YEAR
1992

MODEL
VIGOR

BULLETIN NO.
92-006

Blower Motor Unit Only Runs on High or Whistles

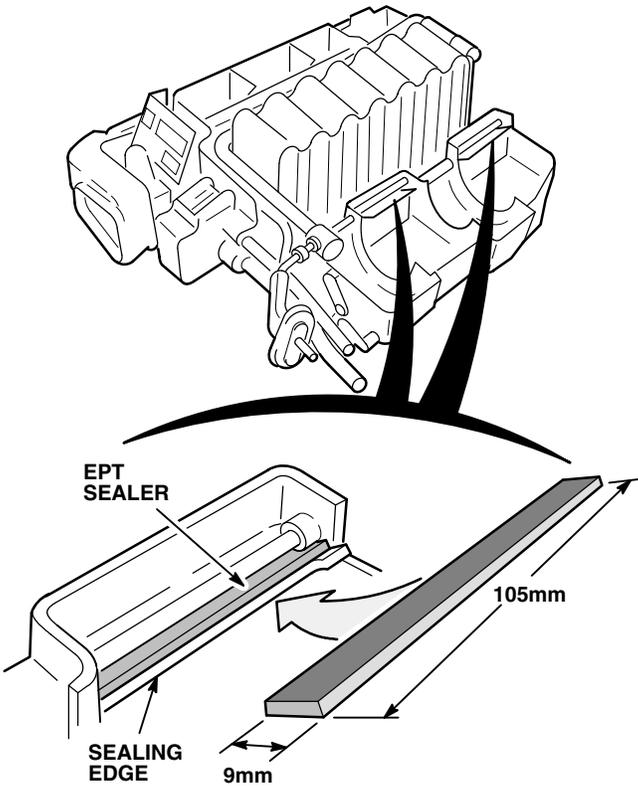
7. Inspect the blower motor connector. If it has a white dot, go to step 10. If it does not have a white dot, go on to step 8 even if the blower motor functions properly.

8. Remove and replace the blower motor following the procedure on page 22-53 of the service manual. Be sure to install the washers on the blower motor shaft first, then install the fans.
9. Replace the power transistor, only if the customer complaint was that the blower motor only runs on high.
10. Inspect the areas shown for EPT sealer. If there is no EPT, apply a 105 x 9 mm strip of EPT sealer 5T to each area. Be sure the EPT is even with the inner sealing edge.

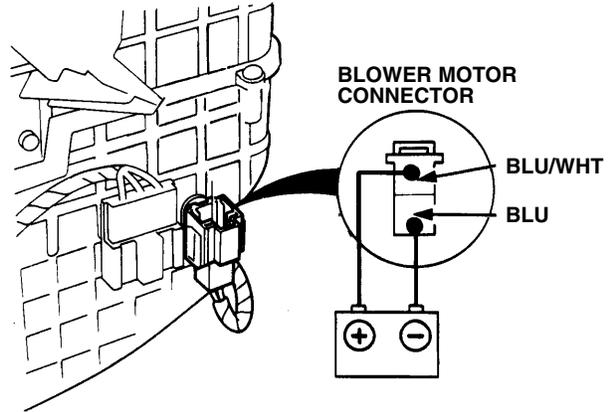
11. Reassemble the heater unit.

12. Bench test the heater unit by connecting a 12 volt battery to the blower motor connector. Listen for air leaks or a whistling noise at the outlet vents.
